SUBDIVISION REPORT

S/D 86-118 - AUTUMN CHASE ADDITION

Final Plat
SUBDIVISION REPORT

S/D No.: 86-118 Name: AUTUMN CHASE ADDITION

AUTUMN CHASE

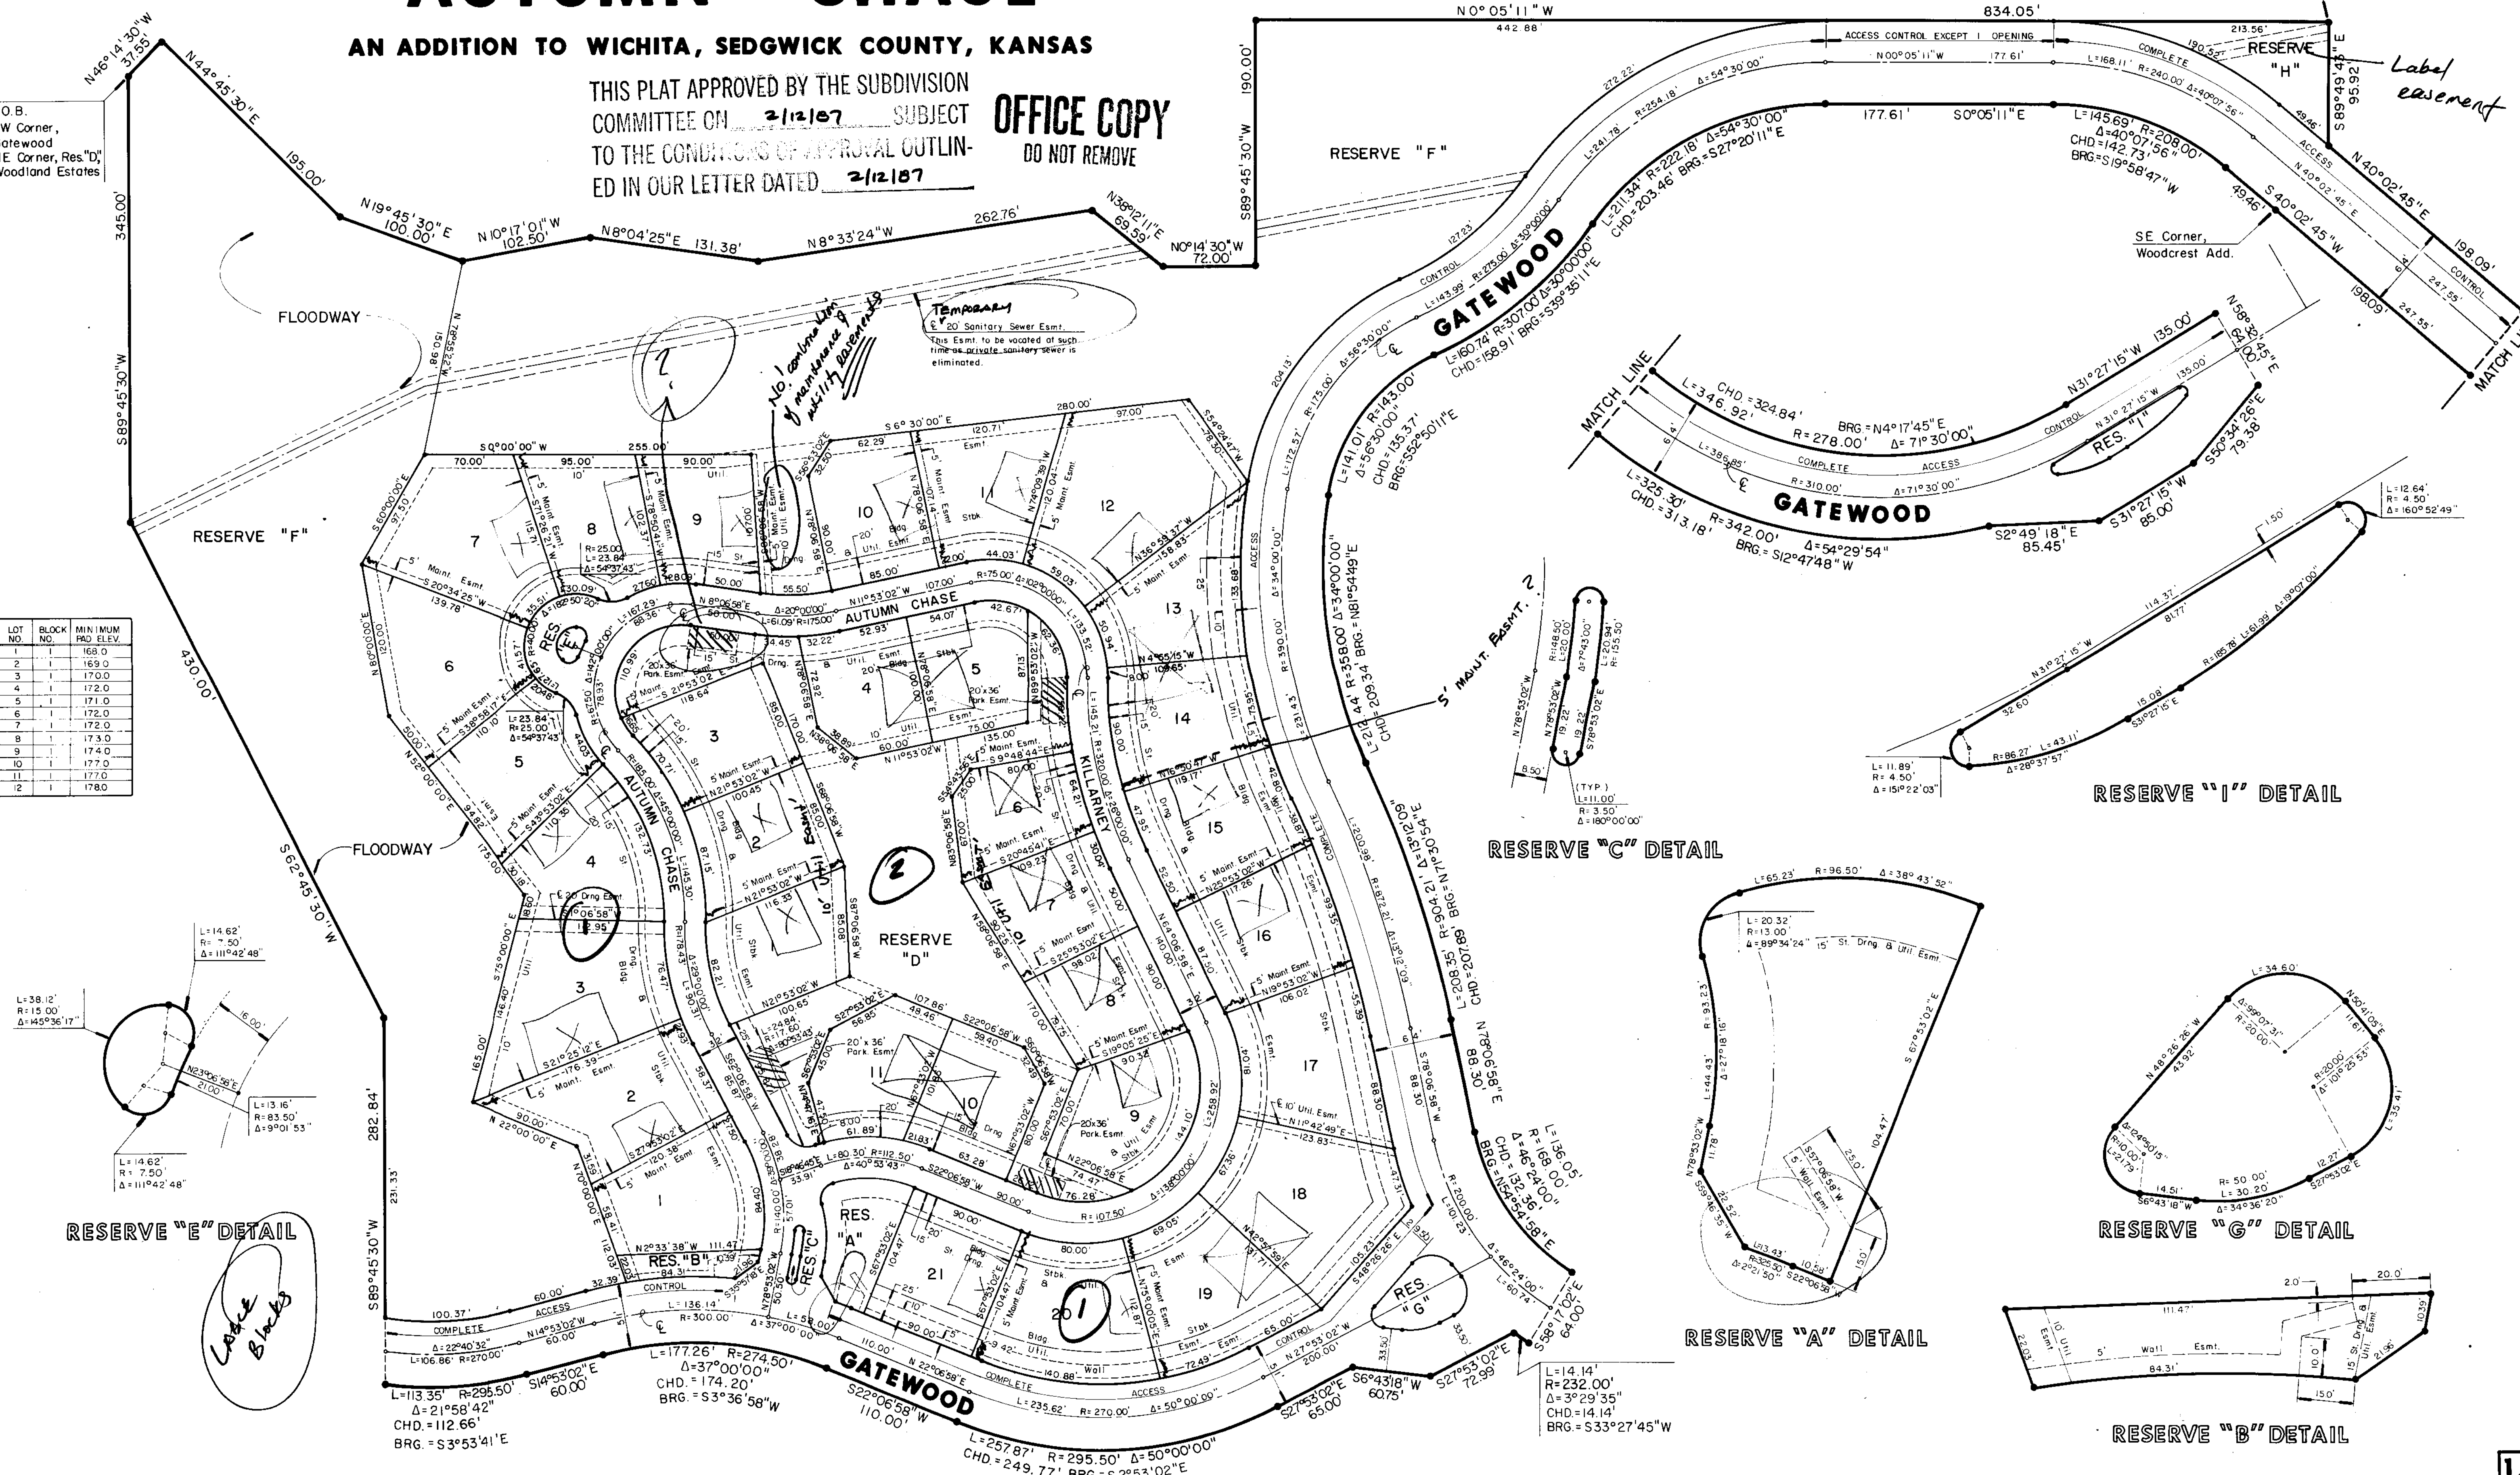
- X. On the final plat tracing, the block designations shown on the preliminary plat shall be depicted on the face of the plat.
- Y. On the final plat tracing, the type and amount of easement being platted on the east 15 feet of Reserve A shall be labeled and dimensioned.

- Z. On the final plat tracing, bearings and distances shall be provided for the centerline of the "temporary utility easement" being platted within Reserve F.

- AA. On the final plat tracing, the portion of the plat's text which references access controls, shall be amended to delete referencing the granting of access control from property which is not within the perimeter of this plat (i.e., "the easterly line of Reserve E, Woodcrest Addition).

- T. On the final plat tracing, the 20-foot wide sanitary sewer easement within Reserve F shall be labeled as a "temporary utility easement". The note included with this easements labeling shall be amended to reference that the "temporary easement automatically is vacated upon abandonment of the private sanitary sewer lateral located in the temporary easement". If the 20-foot easement within Reserve H is a continuation of this "temporary utility easement", it shall be so labeled on the face of the plat and referenced in the plat's text.

- U. On the final plat tracing, the face of the plat shall not depict the continuation of the proposed 5-foot wide maintenance easement into platted street, drainage and public utility easements. The maintenance easements shall also not be shown extending into rear lot line utility easements. The maintenance easement is being platted not only for maintenance of adjacent structures, but also for a 2-foot wide roof overhang. Building overhangs are not permitted within utility, drainage or street easements.

- V. The final plat tracing shall omit the platting of the "5-foot wide maintenance easement" within the 10-foot wide utility easement adjacent to the north line of Lot 9. Roof overhangs are not permitted within utility easements. It is suggested that the 10-foot utility easement be moved 5 feet to the north within Reserve F.

- W. On the final plat tracing, the 10-foot wide utility easement being platted on the rears of Lots 6 through 11 and Lots 1 through 3, Block 2 (interior block as shown on preliminary plat), shall be labeled.

Label
easement
